PLANNING, ZONING, & BUILDING DEPARTMENT
PZ&B Staff Combination Memorandum: Architectural Commission and Town Council

SUBJECT: ZON-23-113 (ARC-23-145) 123 CHILEAN AVE (COMBO)

MEETING: FEBRUARY 28, 2024, ARCOM
MARCH 13, 2024, TC

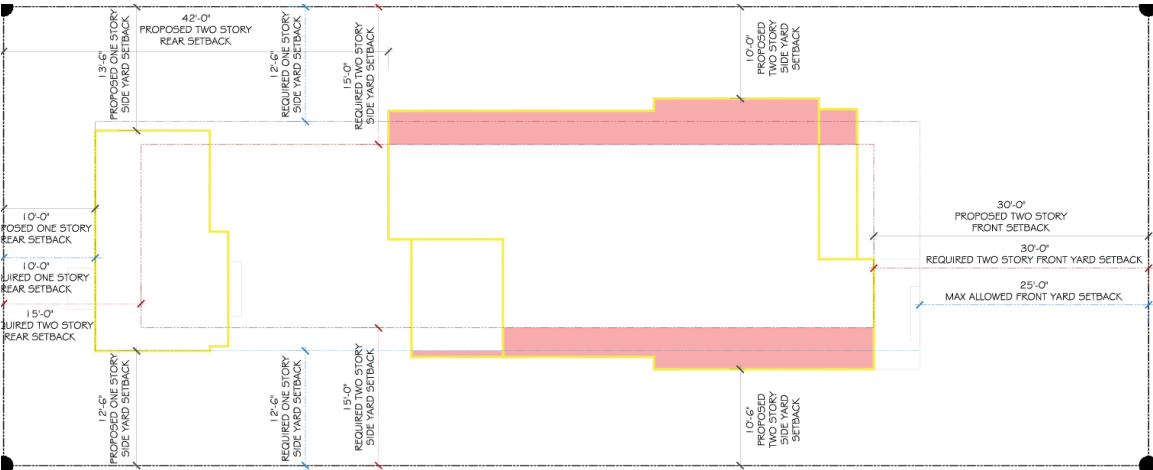
The applicant is proposing the construction of a new two-story residence with detached one-story guest house cabana structure. The primary structure is a condensed stylized version of a Monterey house with a cantilevered balcony on the front elevation that faces south. The front entry has been redesigned to feature a rectangular door with transom light and a front facing gable above. Windows are primarily 6/6 Hartman Mahogany sash windows depicted with white frames. Smooth stucco, shutters and wood detailing completed the finishes. The rear detached cabana which features a single room plus bathroom has side facing gables. Both structures are proposed to have a flat white concrete tile roof. There is a mix of one- and two-story single-family residences on the north side of this block, however, almost all single-family homes on the other side of the street are two story with very similar massing. The applicant has revised the arrangement of openings on the balcony to feature a pair of French doors flanked by 4/4 sash windows. The gable on the primary façade has been widened. The building height has been lowered from 20'-10" to 20'-4", however, the overall building height has been raised from 27' to 27'-7" to the top of roof, with a change of roof pitch. The arrangement of columns at the rear loggia has been redesigned with corresponding changes to the railings above. Small adjustments have been made to the arrangement of fenestration on the east and west sides of the structure. Adjustments were also made to the landscape plan. No changes were made to the detached cabana structure.

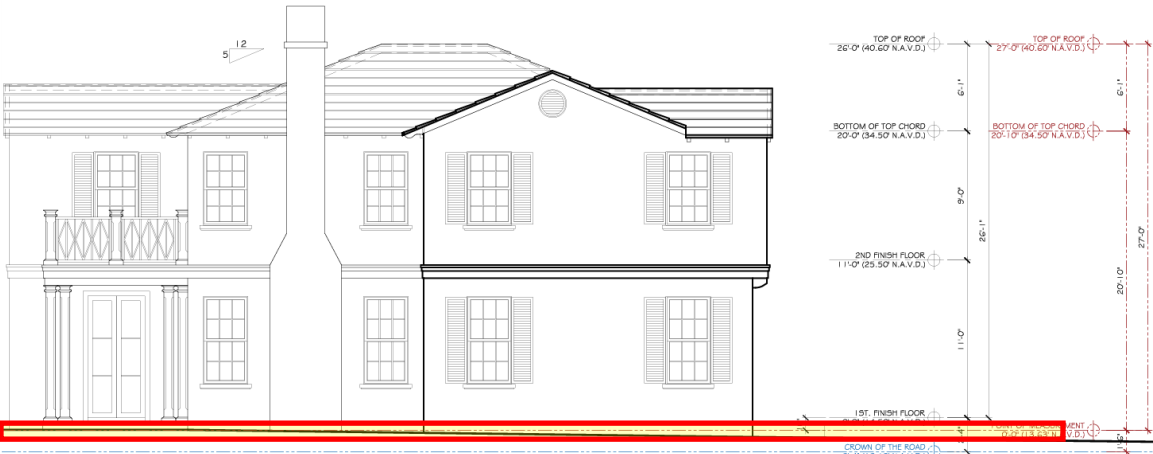
Is it pertains to variance number 3, the applicant is seeking a variance to exceed maximum cubic content ratio (CCR). Staff will note that this is a technical variance which is due to unique aspects of the subject parcel, as it slopes from a higher point at the north, lower to the south. This change in grade causes the point of measurement to start below grade towards the rear of the parcel. While the actual massing of the house is not affected, the point of measurement is prescribed by code, and the resulting overage of cubic content is a result of the point of measurement being below grade.

The diagram below shows how the grade changes slightly, affecting where the point of measurement is taken. Staff does acknowledge that while this technically increases the cubic content of the home, the impact appears to be de minimus.

Neighborhood Capture of Plat of Royal Park Addition

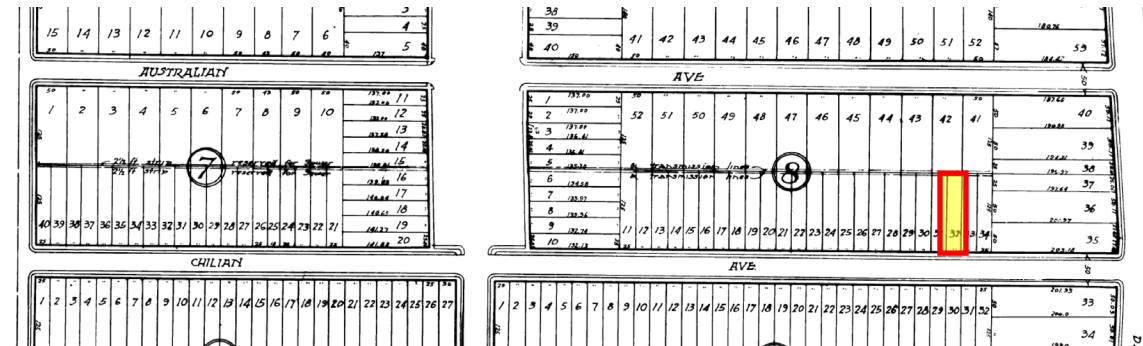
A **Special Exception** is also requested from the Town Council to permit the development of this lot due to its substandard size, yet it is contextually appropriate for the mix of development pattern on this street. A 100' lot width is required, with only 50' existing. And a lot area of 10,000 sq ft is required, with only 6,520 sq ft available. A lot depth of 100' is required, and this property does exceed this requirement with a 125' lot depth. Additionally, the site was previously improved with a single-family residence. A special exception is required to develop a parcel comprised of portions of platted lots. The property is assembled with the East 10 ft of Lot 10, all of Lot 32, and the West

15 of Lot 33 of the Plat of Royal Park Addition.
